1429 ECK ROAD OUTDOOR STORAGE
MAJOR PLAN 2022-109
ATTACHMENTS

TO: PLANNING COMMISSION
FROM: GREGG R. ADAMS, PLANNER
SUBJECT: 1429 ECK ROAD OUTDOOR STORAGE
 MAJOR PLAN 2022-109
REQUEST FOR PRELIMINARY/FINAL PLAN REVIEW
DATE: JUNE 9, 2023
COPIES: BOARD OF COMMISSIONERS, T. PETRUCCI, D. MANHARDT, L. HARRIER,
 L. PERIERA ESQ, A. TALLARIDA, S. PIDCOCK, APPLICANT, SUB. FILE 2022-
 109

SUBJECT: South Whitehall Township
1429 Eck Road Outdoor Storage
Major Plan #2022-109
Preliminary/Final Plan Review

PRELIMINARY/FINAL LANDSCAPING PLAN

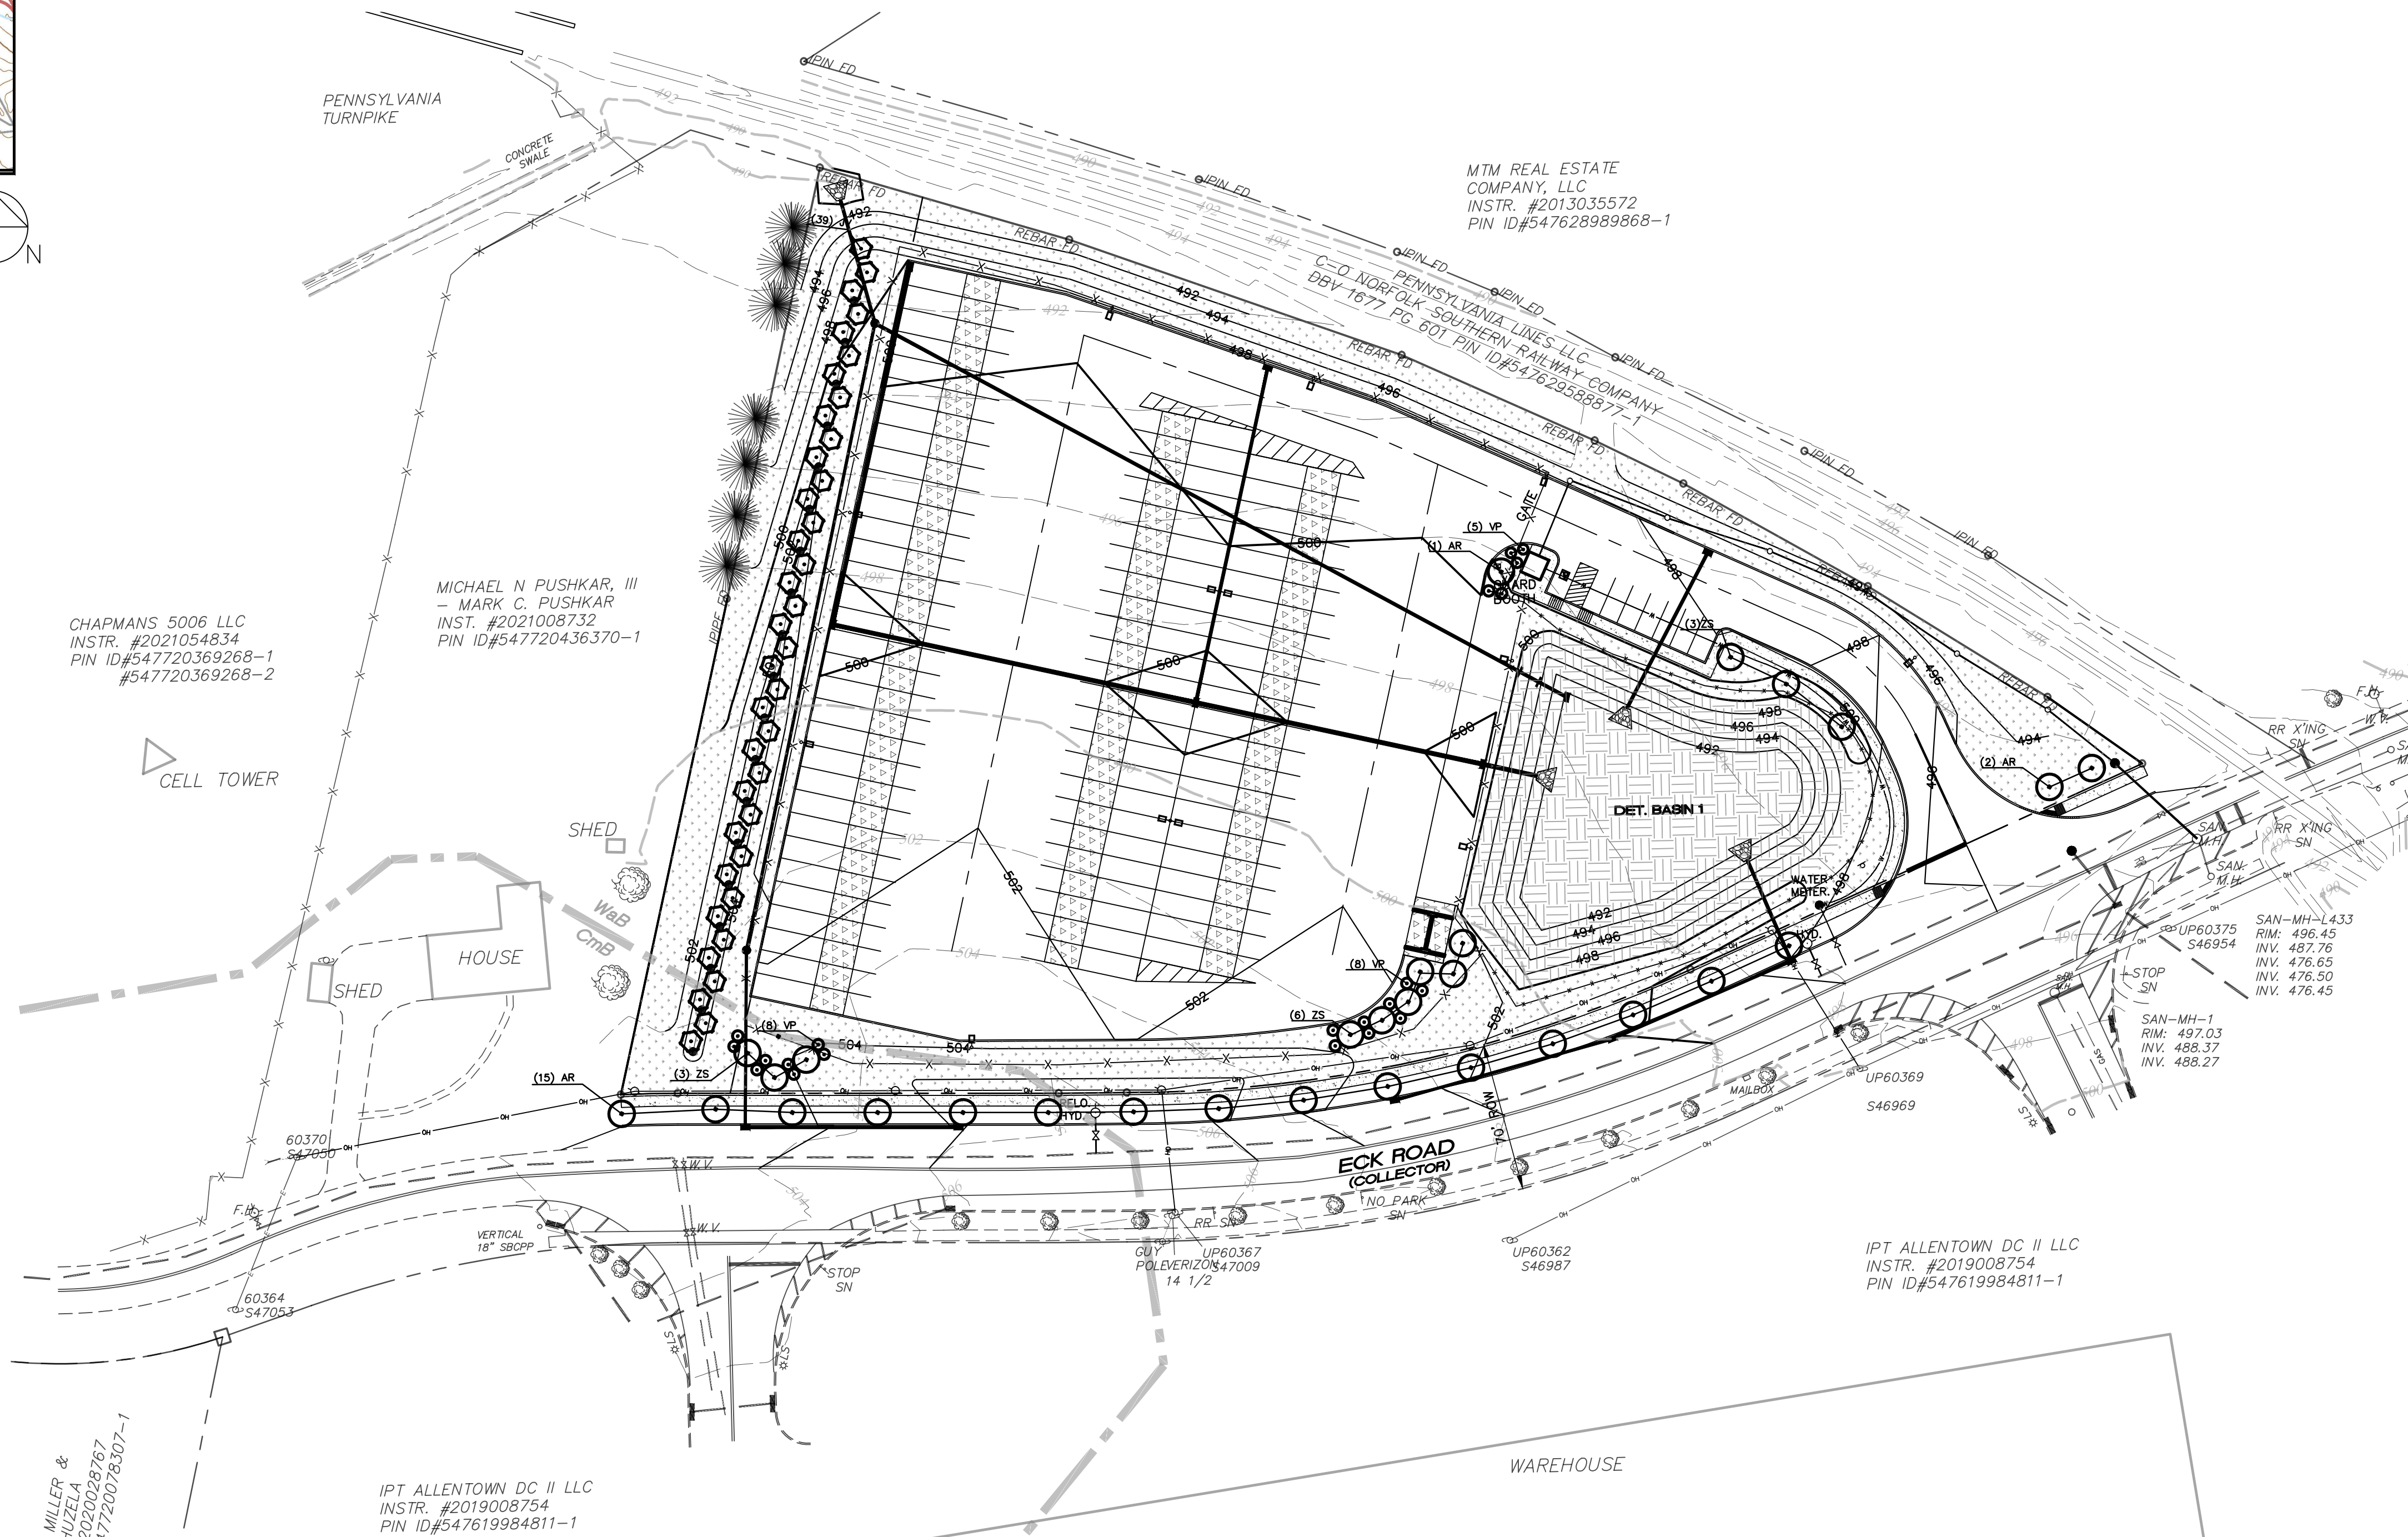
- a. Seventeen Red Maples are proposed as Street Trees. The Selecting Shade Trees Guide states that, if between 11 and 20 trees are proposed, the trees proposed are to be from at least two Families of tree species.

- b. The Shade Tree Commission recommended that species resistant to Verticillium Wilt be used.
 - c. The Commission noted that overhead wires are near the proposed tree locations. It recommended that the species be chosen from the In Tight Areas or Under Overhead Wires categories of Preferred Species.

- d. The Commission also noted that the two southernmost street trees are proposed outside of the right-of-way of Eck Road. The Commission recommended that the trees either be moved to within the right-of-way of Eck Road or be placed within a Shade Tree Easement.

PRELIMINARY/FINAL LIGHTING PLAN

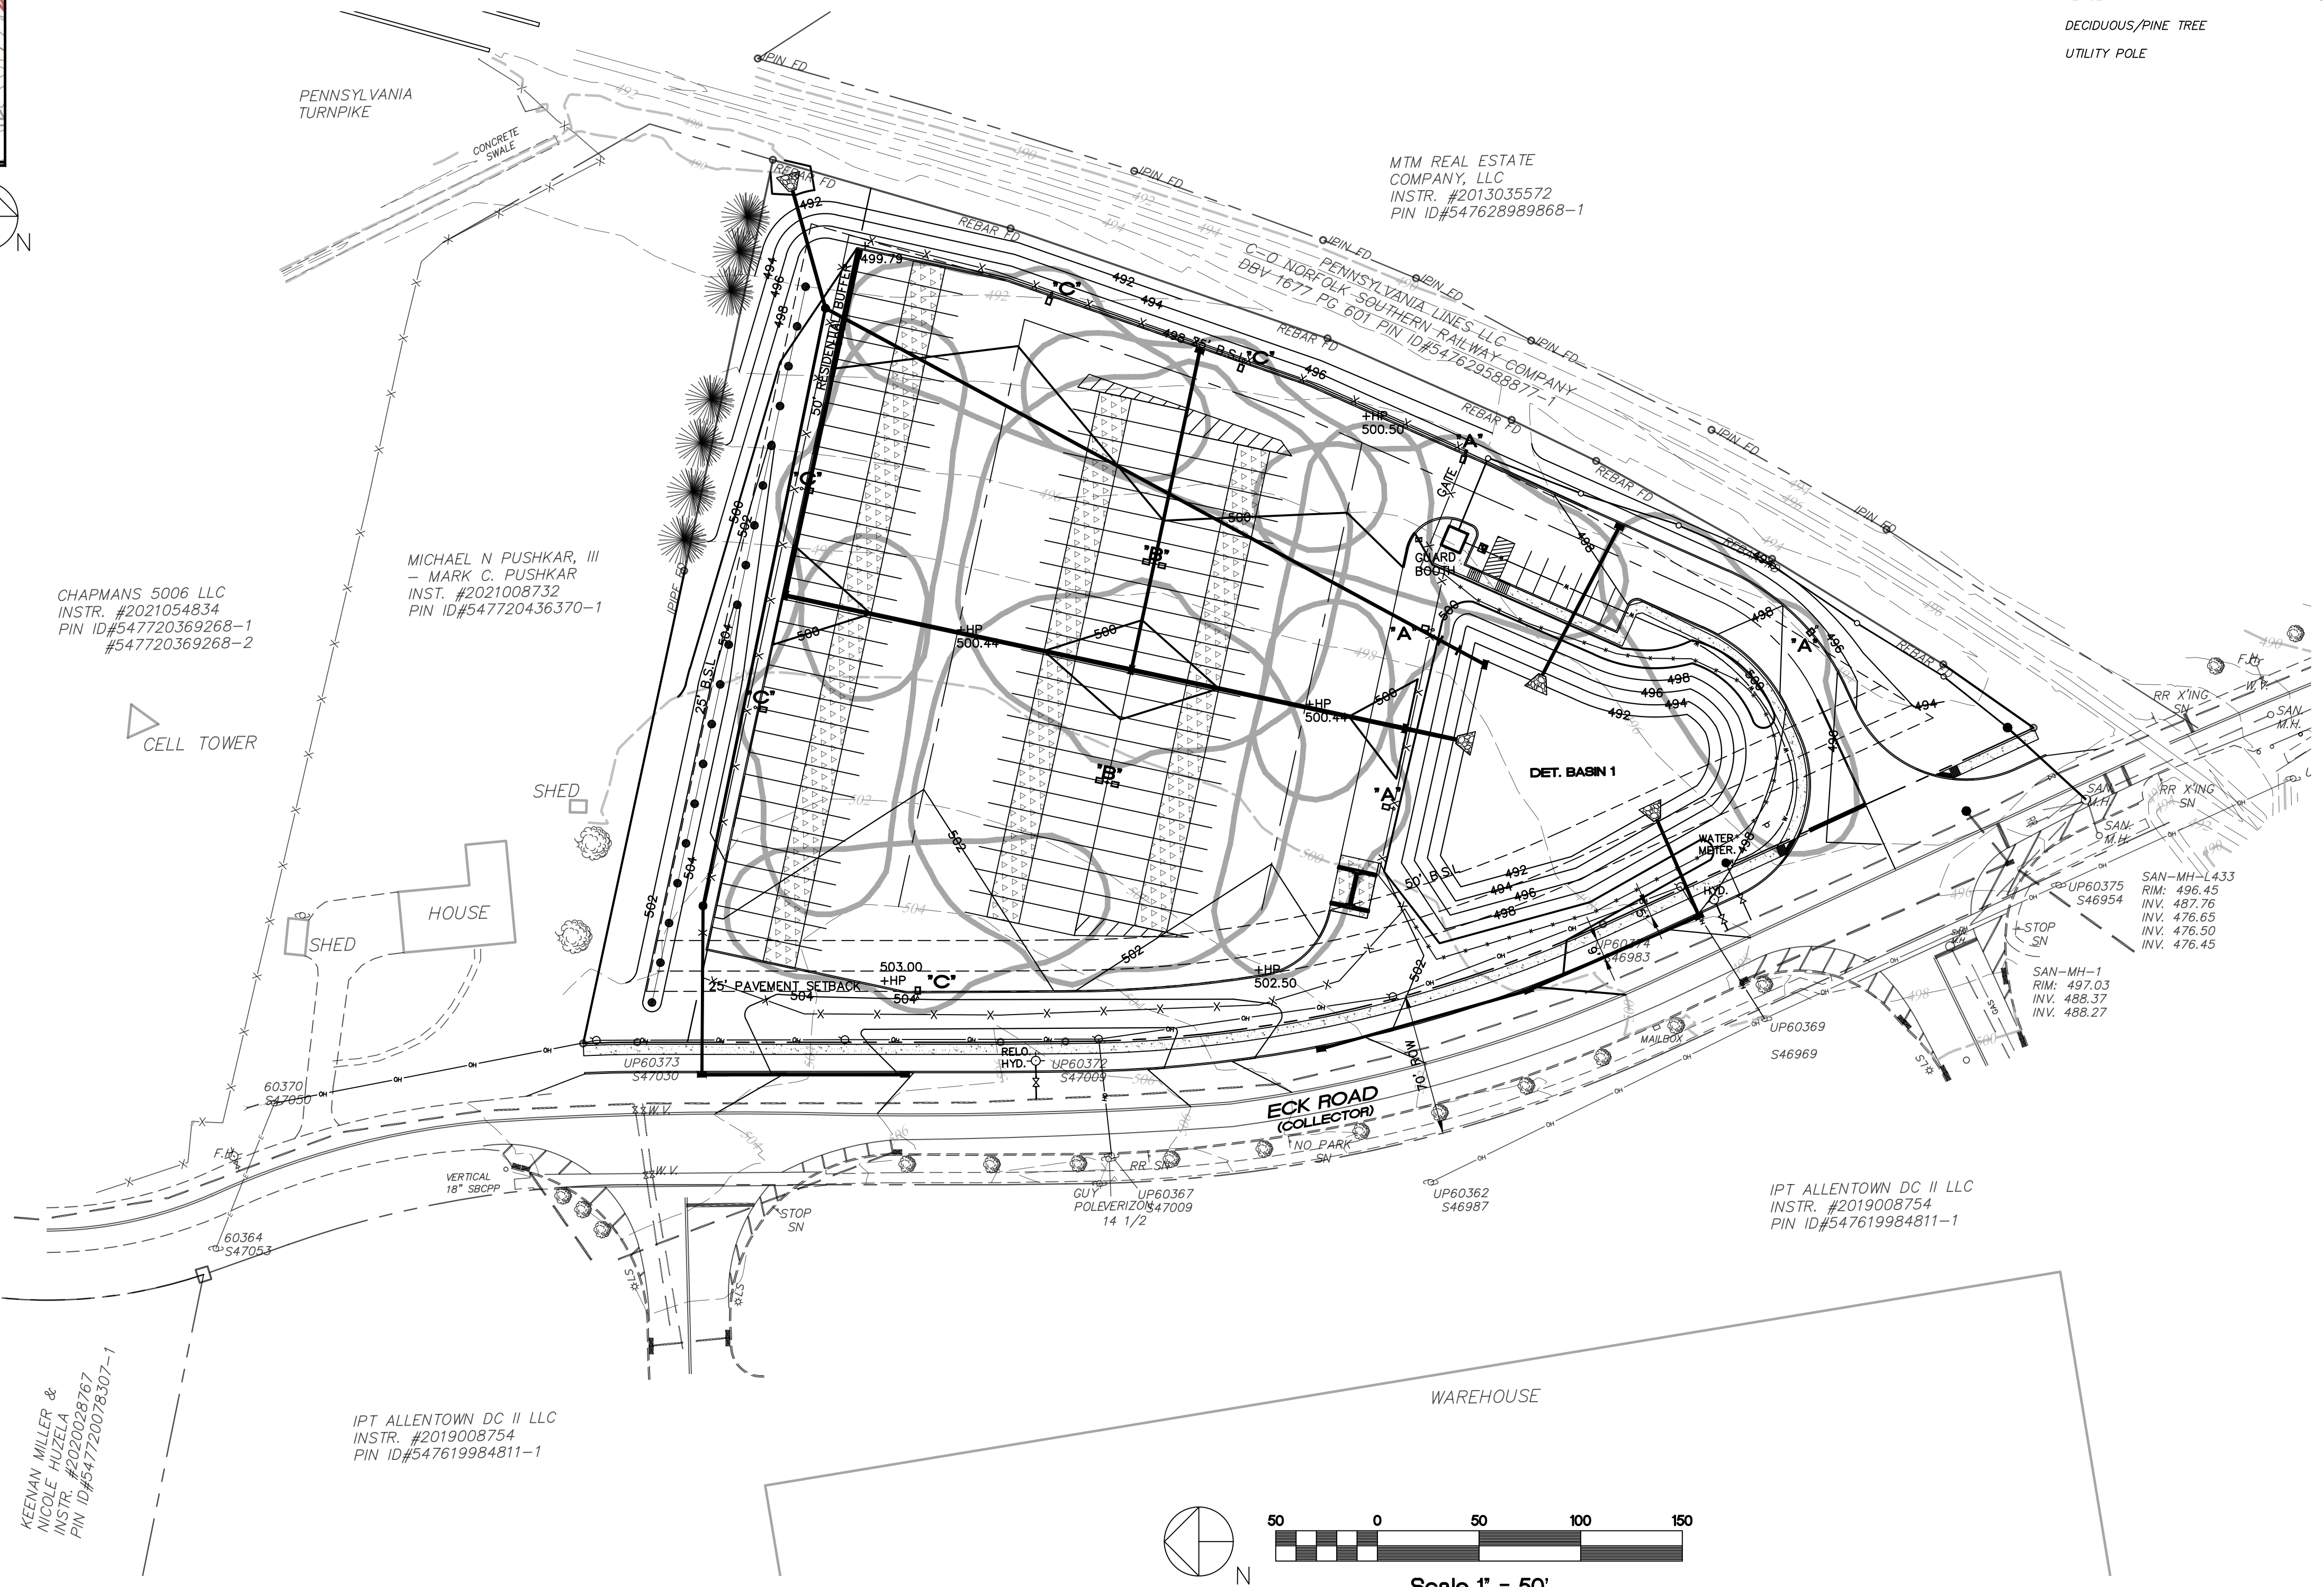
6. We defer to the Township Electrical Consultant to review the proposed site lighting. The Design Engineer should confirm that the proposed light standard foundations will be adequate to support the proposed light standards;
7. Matters pertaining to the design of water distribution and sanitary sewerage systems should be directed to the Department of Public Works. We have not reviewed these designs;
8. Revise the Planning Commission Signature Block to be consistent with SALDO §312-13(d)(2); and
9. Upon submission of plans for recording, all Statements and Certifications shall be signed and sealed/notarized as applicable, SALDO §312-14(b)(2). The Township Solicitor should determine the acceptability of the Engineer's Statement, SALDO §312-12(b)(5). Also, update the Certification of Owner of Record to be consistent with SALDO §312-12(b)(6) and §312-14(b)(2).
